Subject: May 6, 2010 Inspection

The bullets below represent Berkshire Power's responses to the Region's comments, including remedial action and/or future intent:

Oil and Water Separator #3 (OWS - 3)

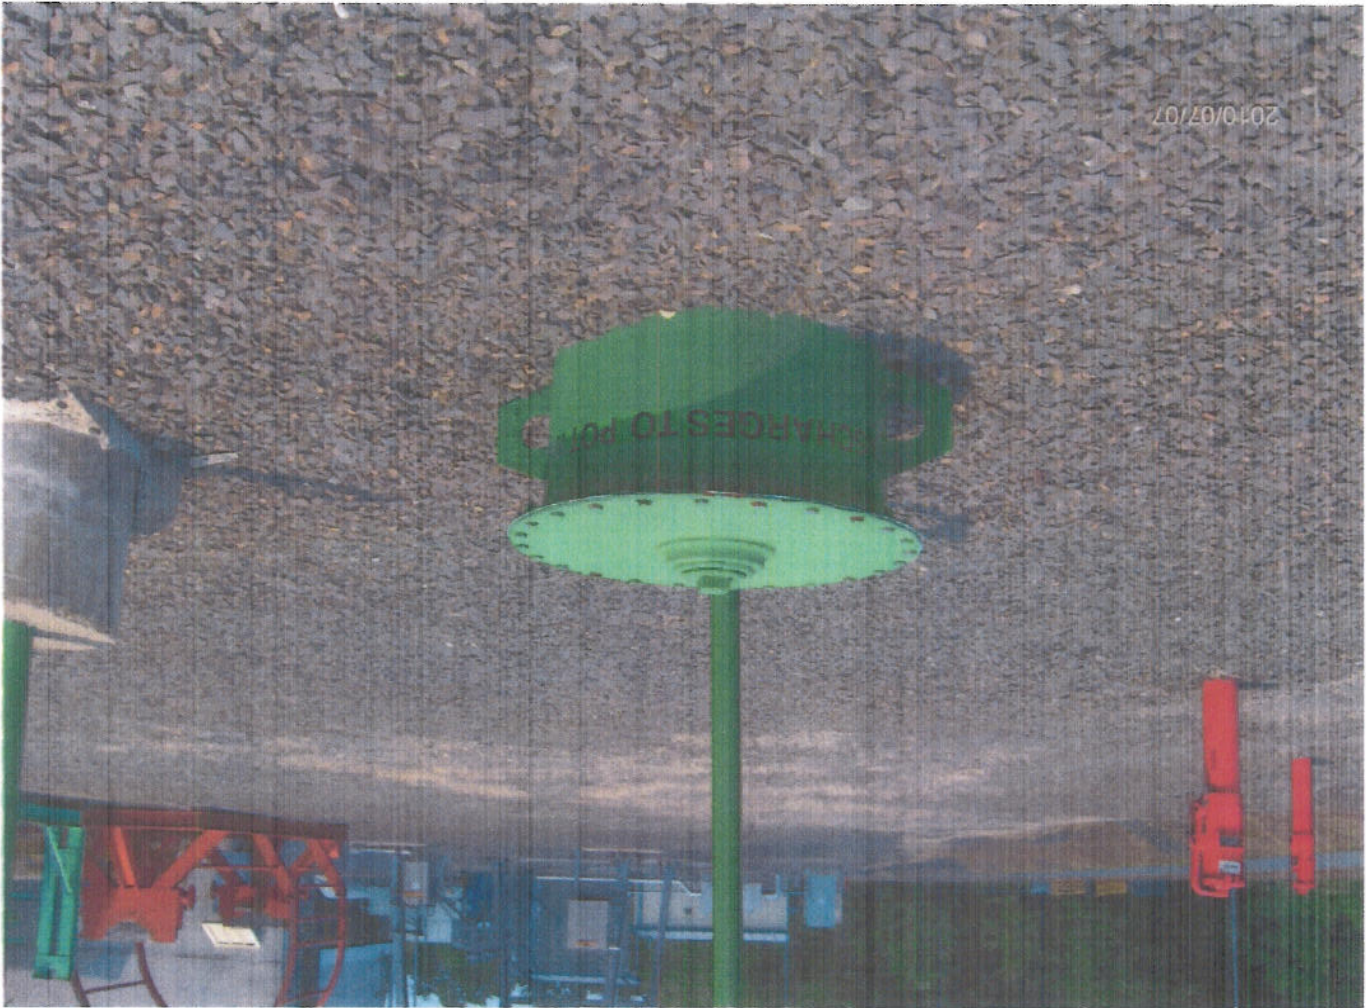
- The outfalls have been clearly labeled and marked. Please see the attached photos. The design of the detention basin storm water discharge provides for final release of clean storm water effluent to the wetlands which drains to the Worthington Brook. The outfall is on Berkshire Power property, but it is outside of the fence-line. Access is achieved by Shoemaker Lane.

New labeling showing POTW Discharge

Wastewater Sampler

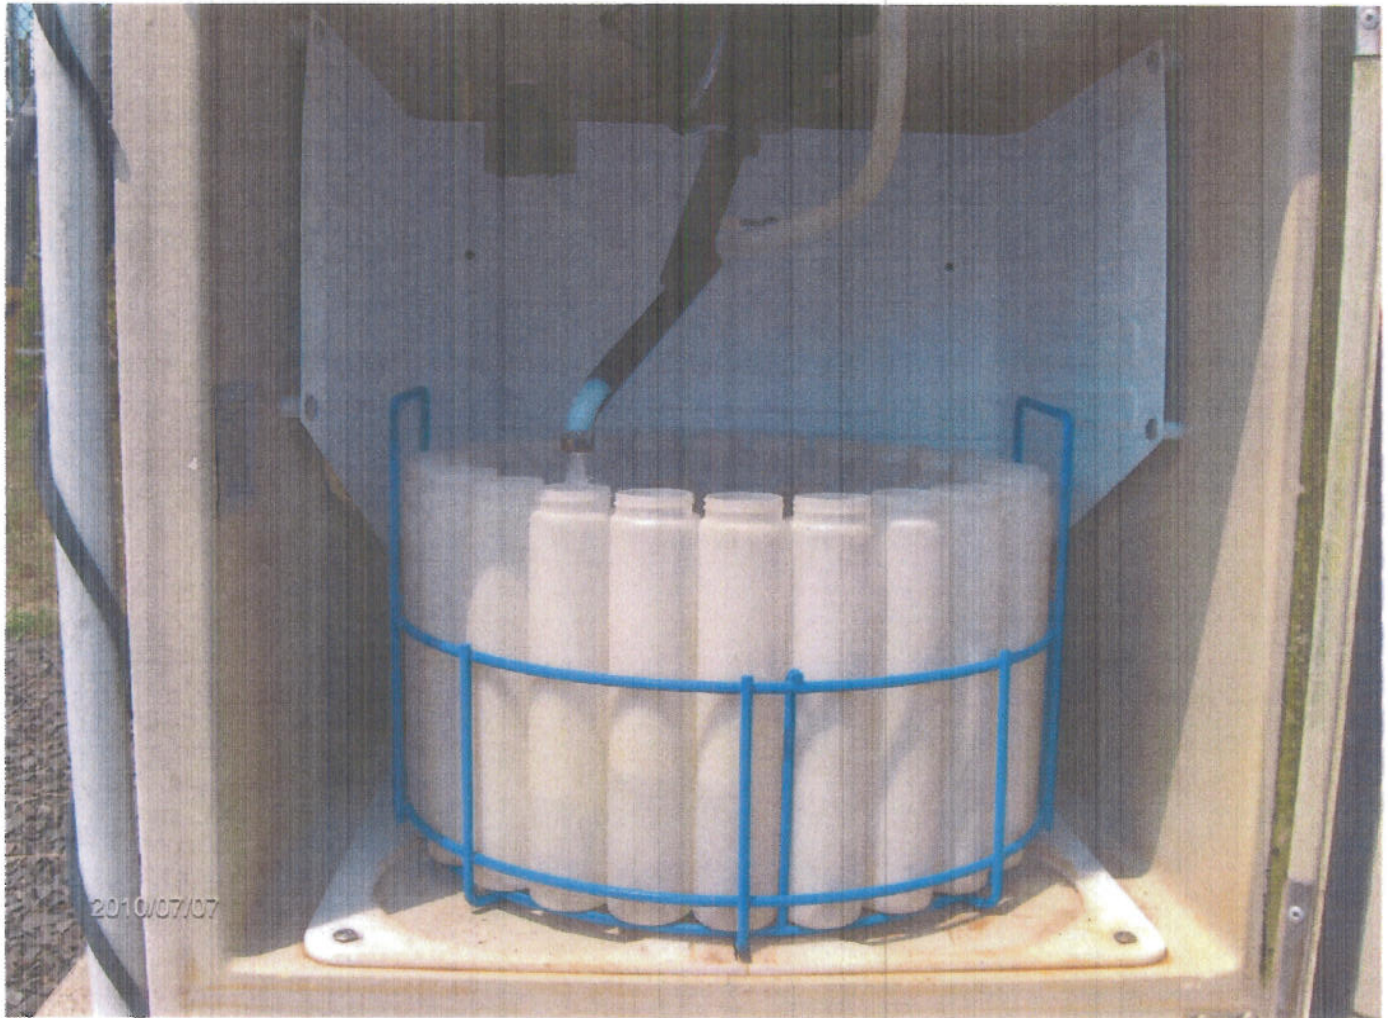
- Immediately following the May 6th inspection Berkshire Power thoroughly cleaned the automatic waste water sampler. Additionally, the bottle rack was removed, sand-blasted, painted with an epoxy coating, and re-installed. Please see the attached photos of the current condition of the sampler following the remedial work.

The Wastewater Sampler was cleaned and the bottle rack was removed, sand-blasted and painted.

Ammonia Tank

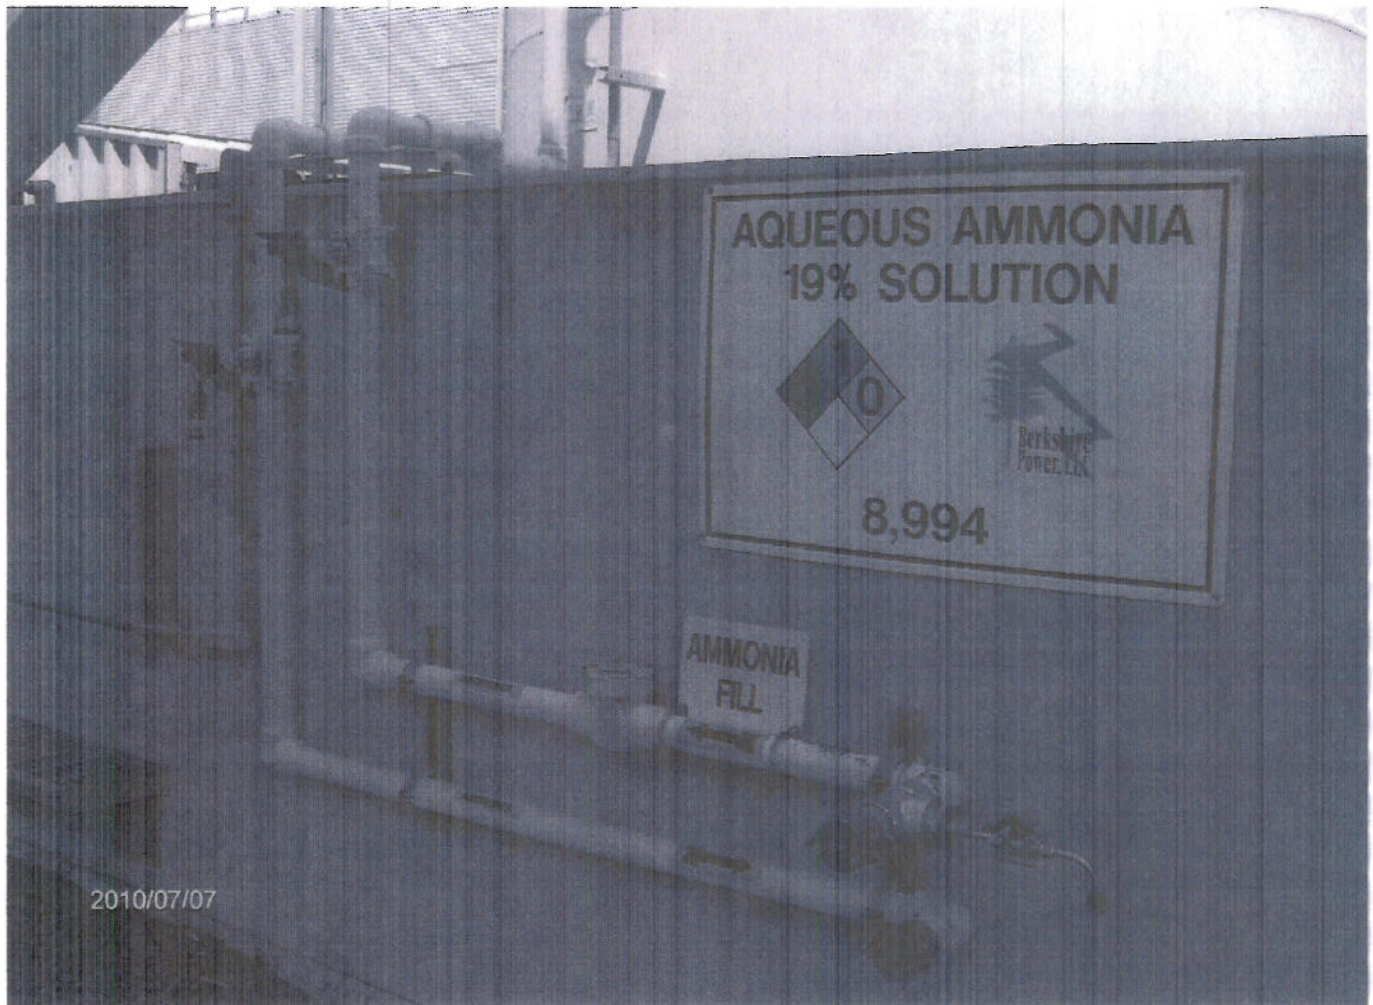
- As seen in the attached photos, Berkshire Power has installed locks on the supply and return (truck transfer) lines, as recommended by the Region.
- As you pointed-out, storm water samples should ideally be collected at the final outfall of the detention basin. As the detention basin percolates, storm water rarely reaches the v-notch weir outfall. As such, Berkshire Power alternatively draws storm water samples at four culverts which represent influent points to the detention basin. This provides representative samples of the final storm water effluent. Pursuant to the Region's recommendation, Berkshire Power may choose to perform visual storm water assessments, in lieu of actual sample collection, as there is no actual discharge. Currently, the facility continues to diligently collect samples at the detention basin influent culverts, but may revert to visuals only; at which point, Berkshire Power will modify the SWPPP and SPCC Plans, describing the change.

Locks applied to inlet and outlet isolation valves at Ammonia Tank.

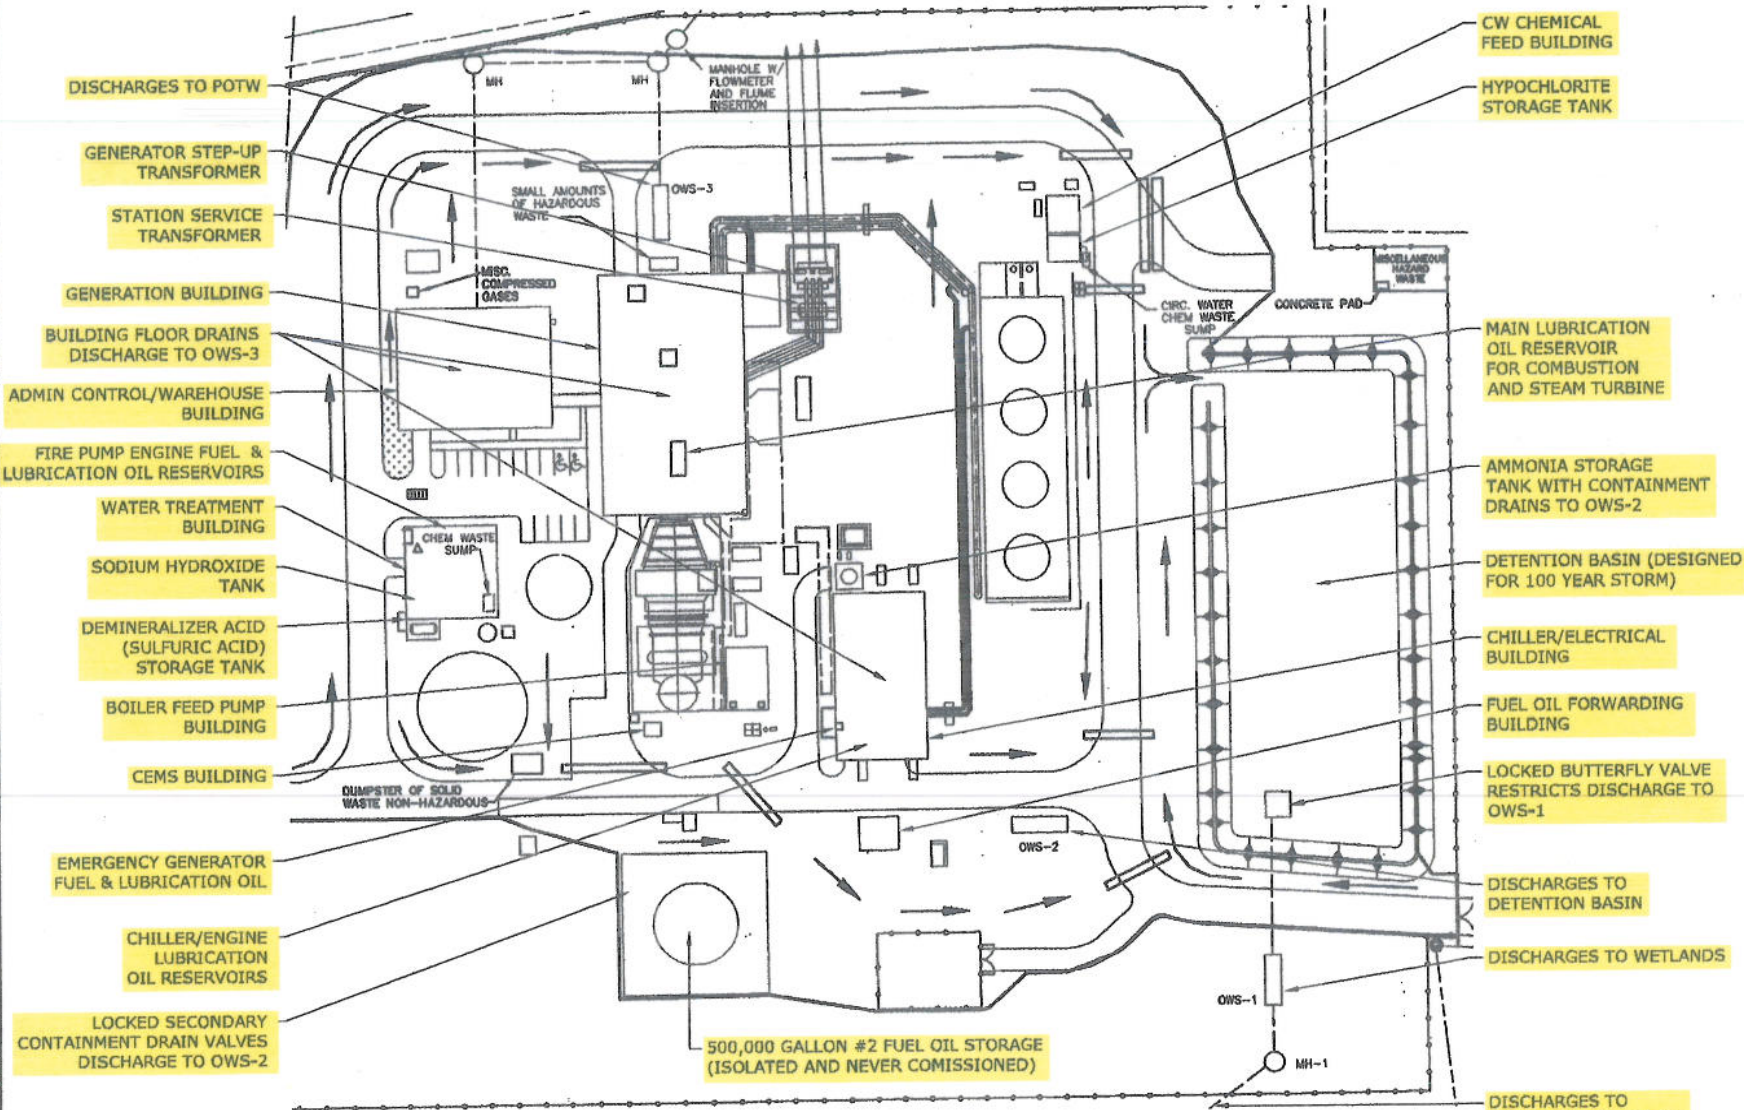
- A simplified site plan detailing chemical/oil storage areas, floor drainage and respective OWSs, detention basin capacity, v-notch weir and associated shutoff valve, and POTW designation has been developed. Attached is a reduced version. A color-coded large "C" – sized drawing has been added to the plans. Also, building floor drains have been stenciled, as shown in the attached photo.
